# UNITED STATES PATENT AND TRADEMARK OFFICE

APPLICATION NO.	FILING DATE	FIRST NAMED INVENTOR	ATTORNEY DOCKET NO.	CONFIRMATION NO.
10/537,096	06/02/2005	Kevin Sydney Lansdown	A-9614	8820

# Office Action Summary

FIG. 1

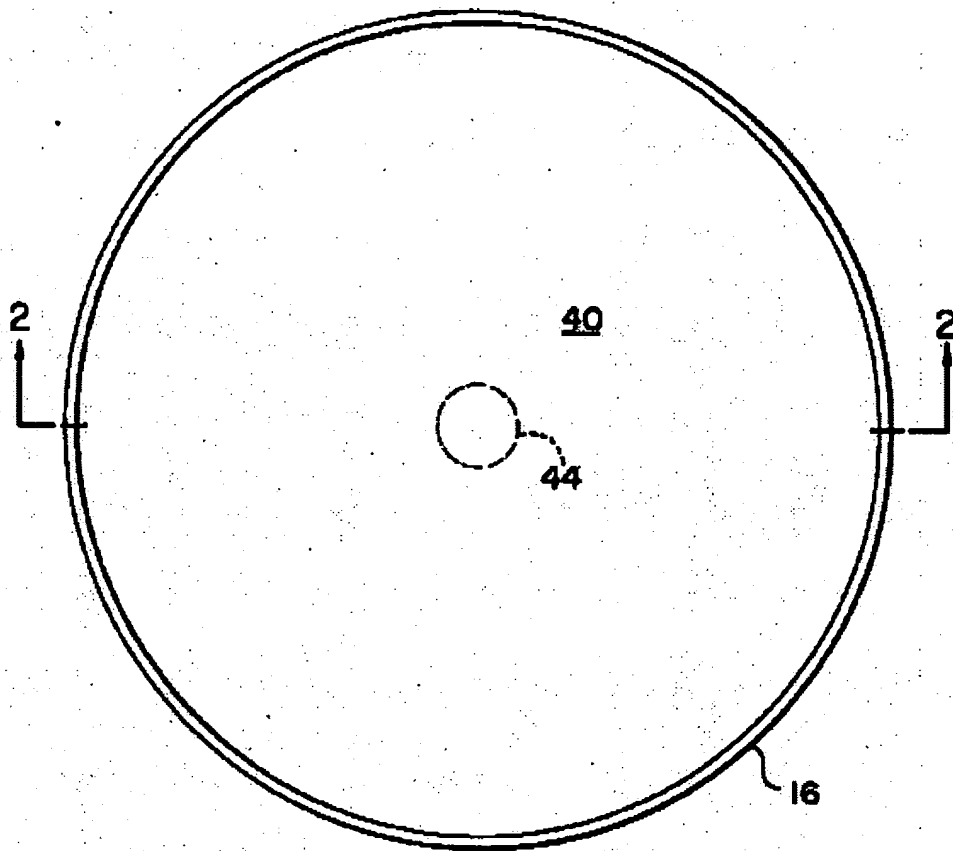
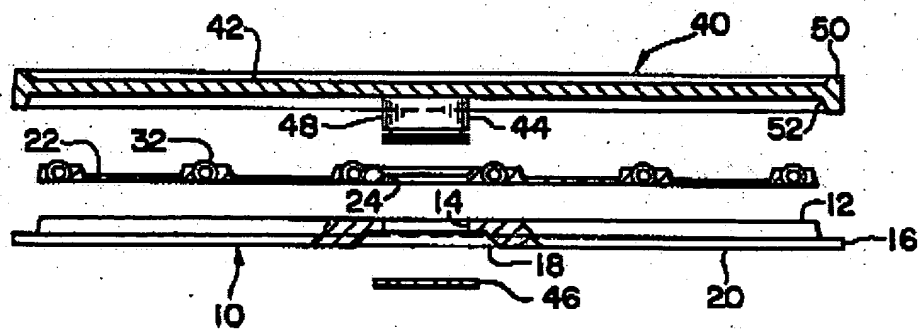
Claims 22-29,32,33,and 36-41 are rejected under 35 U.S.C. 102(b) as being anticipated by Blevins et al. (US005479867). Referring to figures 1 and 2, and further in view of the aforementioned interpretations in the objections and rejections sections, Blevins teaches a rotary table with a platform(40) that has a substantially planar upper surface and a base(10) with the platform supported on the base by a rotation means further comprising bearing means which are radially spaced from the center of the platform and base where the bearing means comprise ball bearings, further comprising constraining means comprising a ridges(50) that are provided on opposite sides of the platform that define recesses defined by the ridges(42) that is capable of receiving and restraining the wheels of a trash container, further with the ridges converging toward each other from the front end of the platform to the rear end, with any section being the front as the ridges are in the form of a circle which converges with itself at any point on

the outer edge of the platform, further with a ridge at the rear of the platform that could act as a stop to restrain a waste container, again with any section being named the rear, whereby the ridges define a platform area that would be complementary to a cross section of a waste container with the same shape. The platform further being rotatable from a first position to a second position approximately 180 degrees from the first position. Further with any portion being an entry/exit for an article received on the platform where the entry/exit is bounded at least on opposite sides by said ridges.

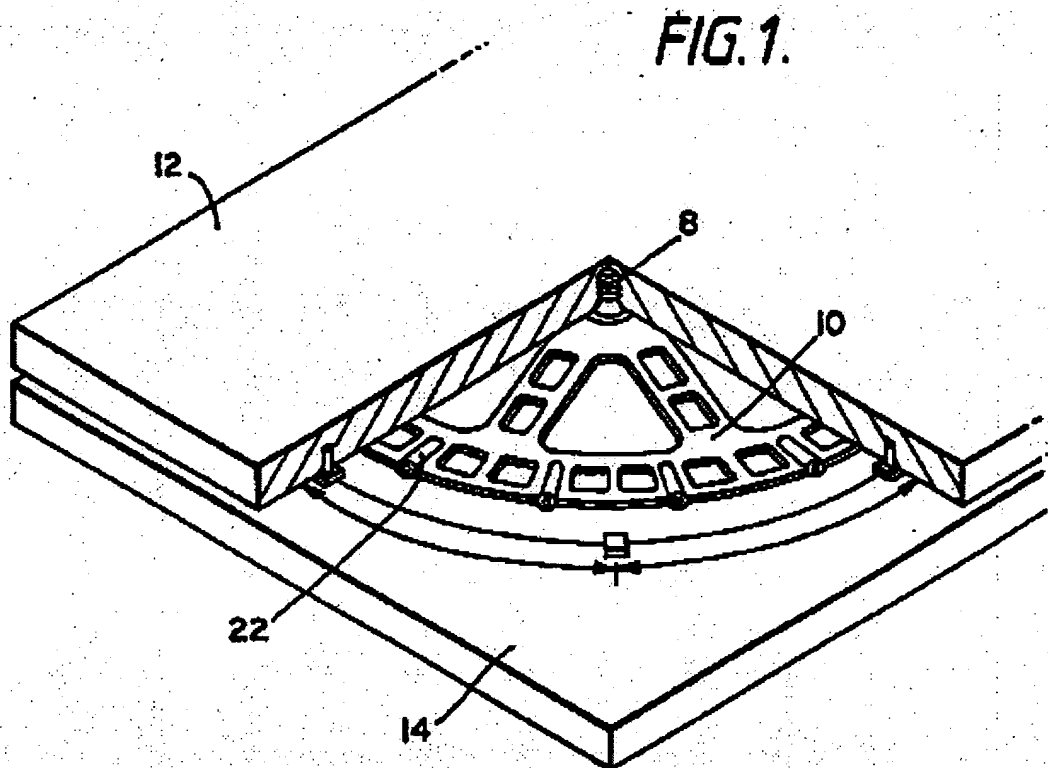
Claims 30,31,and 35 are rejected under 35 U.S.C. 103(a) as being unpatentable over Blevins et al as applied to claims 29 and 32 above and further in view of Harley(US005080322). In regards to claims 30 and 31, Blevins teaches the use of a rotation means comprising an axel member attached to the platform, however Blevins does not teach the use of a axel means located in aligned apertures arranged centrally in the platform and base, with said axel means comprising a pin that connects the platform and base. Referring to figure 1, Harley teaches a turntable similar to that disclosed by Blevins, wherein the axel means comprises a pin(8) aligned in apertures centrally located on the platform and base, whereby the pin connects both the platform and base. It would have been obvious to one of ordinary skill in the art at the time of invention to replace the axel means of Blevins with the axel means of Harley, because such an arrangement would have the same functionality as the original axel of Blevins

and could be construed as a simple design choice. In regards to claim 35 Blevins teaches the use of ball bearings as his bearing means, however the use of rollers is not disclosed, Harley however discloses the use of rollers(22) as bearing means on a turntable. It would have been obvious to one of ordinary skill in the art at the time of invention to replace the ball bearings of Blevins with the rollers of Harley, because as the applicant discloses, these are both bearing means and the substitution of one for another was seen as a design choice and not critical to the operation of the present invention.
